APPLICATION NO.	FILING DATE	FIRST NAMED INVENTOR	ATTORNEY DOCKET NO.	CONFIRMATION NO.
10/781,527	02/17/2004	Edward R. Katz	741501-1053	2433

Office Action Summary

DETAILED ACTION

FIG 1

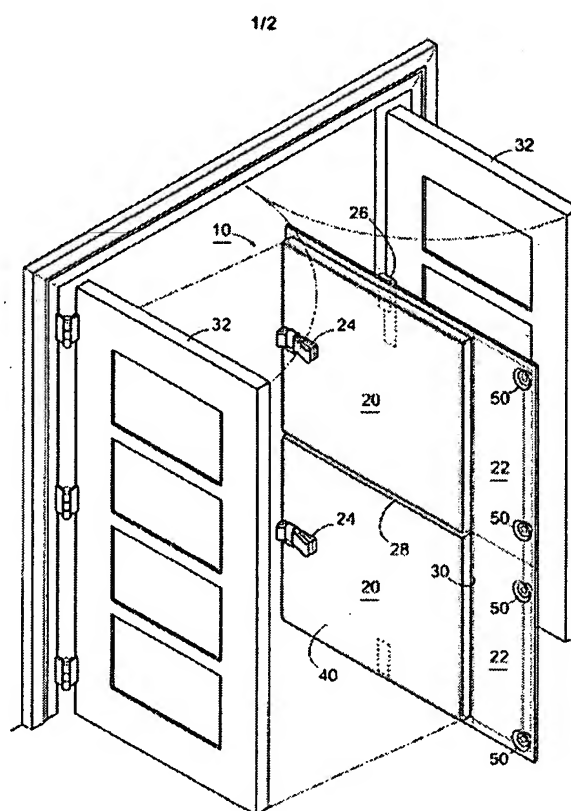
1. The drawings are objected to under 37 CFR 1.83(a). The drawings must show every feature of the invention specified in the claims. Therefore, the “plurality of ribs” discussed in claims 6 and 7, along with the main protective sleeve of claim 10 must be shown or the features canceled from the claims. No new matter should be entered.
2. The drawings are objected to because figures 1 and 3 are inconsistent with respect to the minor flap (22) as shown below.

In Figure 1 it looks as if the minor flap is large and spans the entire area of the main section (20). Figure 3 illustrates the minor flap to be a small arm or attachment to the rigid sheet.

Corrected drawing sheets in compliance with 37 CFR 1.121(d) are required in reply to the Office action to avoid abandonment of the application. Any amended replacement drawing sheet should include all of the figures appearing on the immediate prior version of the sheet, even if only one figure is being amended. The figure or figure number of an amended drawing should not be labeled as "amended." If a drawing figure is to be canceled, the appropriate figure must be removed from the replacement sheet, and where necessary, the remaining figures must be renumbered and appropriate changes made to the brief description of the several views of the drawings for
